CITY OF CARPINTERIA
ARCHITECTURAL REVIEW BOARD
Meeting of February 12, 2015

Agenda Item # D-2

COMMUNITY DEVELOPMENT DEPARTMENT PROJECT REVIEW

Project: 15-1751-DP/CDP **Planner:** Steve Goggia
Address: 5775 Carpinteria Avenue
APN: APN 001-170-018
Zoning: Community Facility District (CF)
Applicant: Matt Roberts, Director of Parks and Recreation

SHEET
L-3.1

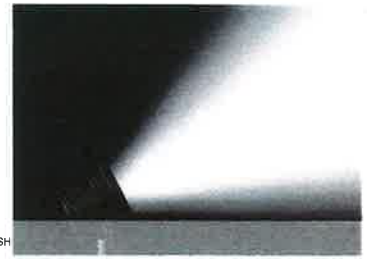
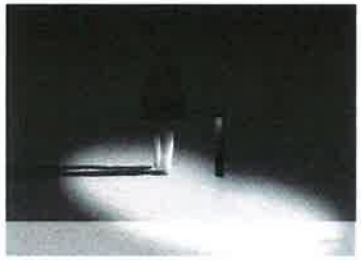
The proposed lighting is shown on the Landscape Plans; the fixtures are shown on Sheet L3.1. With the exception of the LED floodlights proposed to illuminate the monument signs, the fixtures are night sky friendly. Staff would appreciate the Board's input on the proposed fixtures in the effort to minimize photopollution to the maximum extent possible.
